From: [REDACTED]
Sent: 12 May 2026 22:10
To: Norwich to Tilbury
Cc: [REDACTED]; Burstall Parish Council; [REDACTED]
Subject: Re: Norwich to Tilbury – Project Update Notification

Burstall Parish Council Submission 12th May 2026

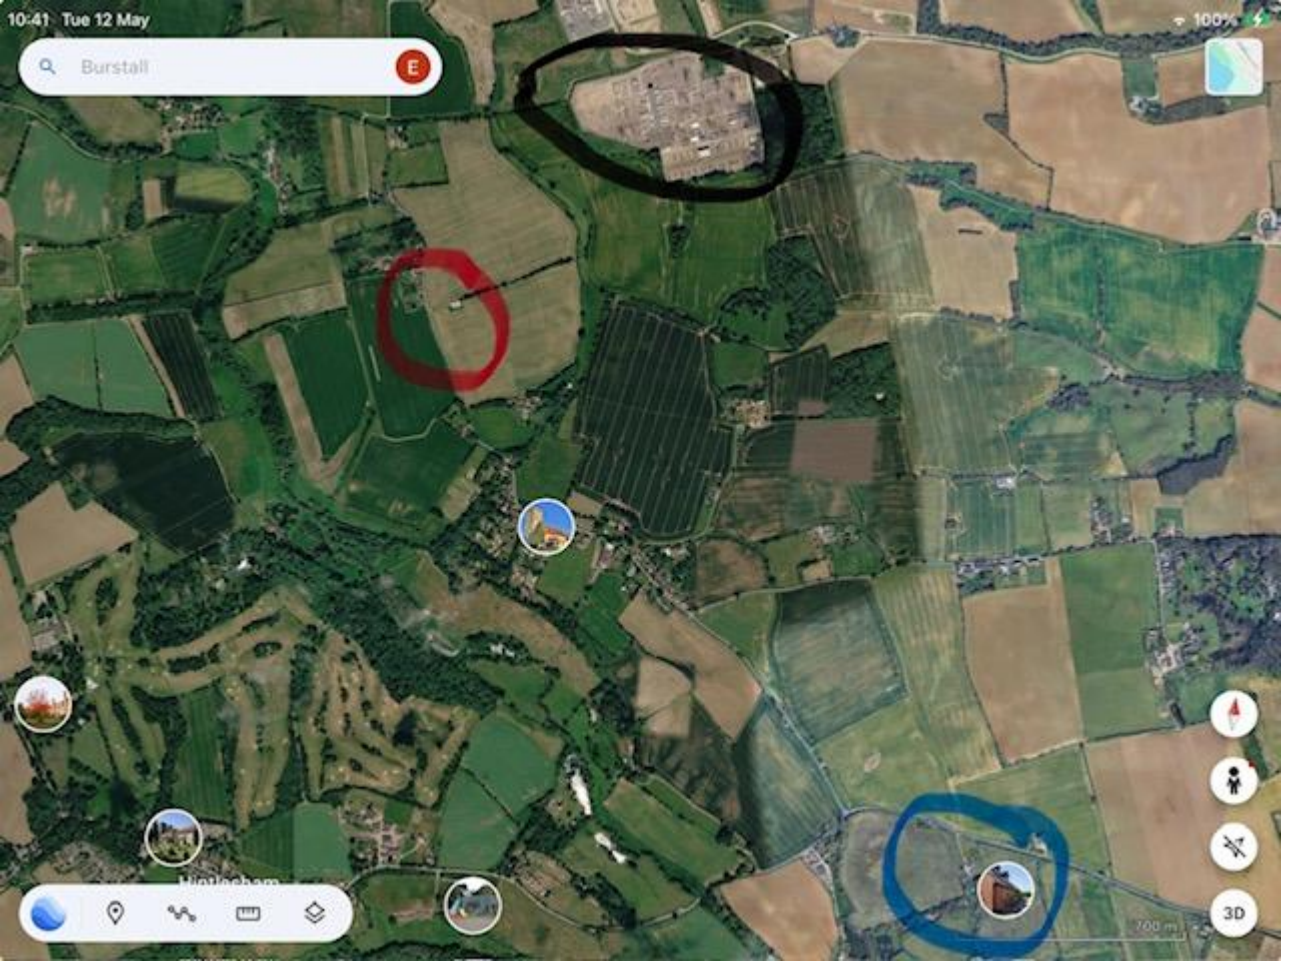
We are disappointed that the ASI route does not take into account the impact of the Bramford Substation wirescape to the village of Burstall. From the outset of the examination we have requested such a visit. Our Deadline 4 submission will make it very clear what mitigation has been proposed, is achievable, but to which we have not received an adequate response.

A small, simple but necessary diversion to your ASI route would be to the Orchardlands area of Burstall (map below - blue circle is the current proposed 10:05Hrs stop to see 'landscape and visual effect to residential visual amenity'; red circle is the proposed additional stop to see arguably the most impacted visual amenity of the entire route; black circle is the Bramford Substation for orientation). Here a clear view of the substation and the impact of existing/ proposed wirescape can be seen. These views will not be achievable from your proposed stop alone. I would be more than happy to meet you there to describe the lack of mitigation and the simple proposals to mitigate.
